# Model 1208 - 6 Meter Transverter - PC Board Error

(The arrow in the figure below shows the portion of the junction grounded by the board fault.)

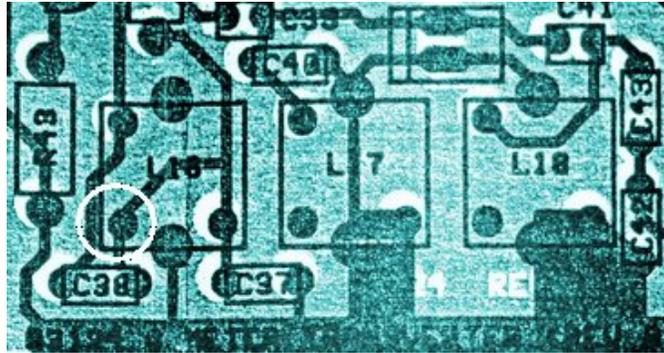
On my board the 3<sup>rd</sup> hole on L16 connected the upper ground plane to a trace on the underside of the board from C37, C38, R44 and L16 effectively taking all these components to ground. A quick review of the schematic shows this is an error.

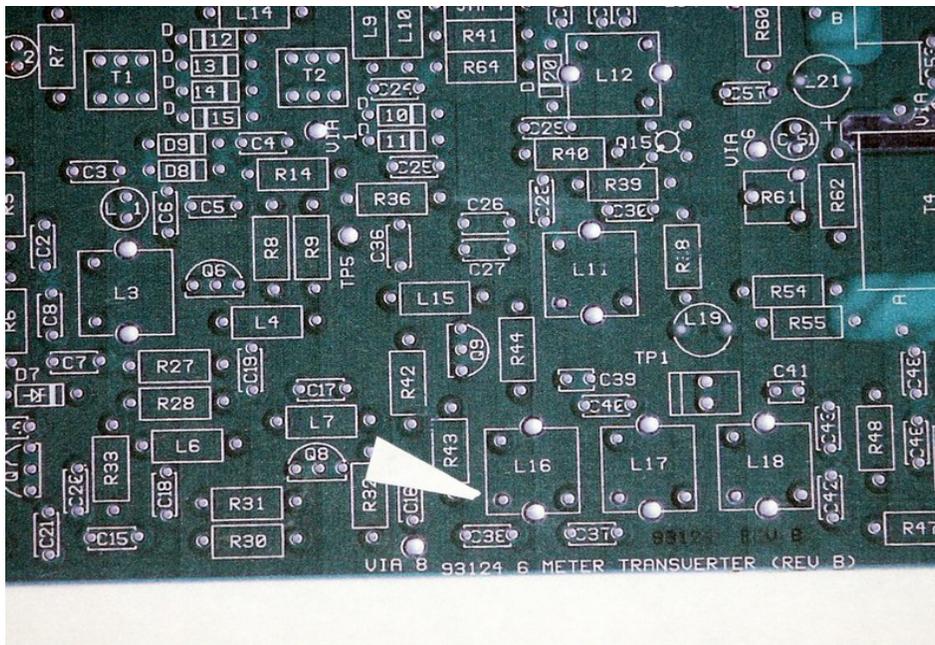
Examination of the X-Ray view shows the problem (see pad inside white circle at lower left of L16). The L17 and L18 pads connect the top ground plane to bottom ground plane BUT L16 connects the top ground plane to a trace on the under side. (Green is component side ground plane, black is underside trace, underside ground plane NOT shown.)

The hole in question (see photo below by the white arrow) was drilled from the top side *just deep enough* to ensure that it no longer was connected to the upper ground plane.
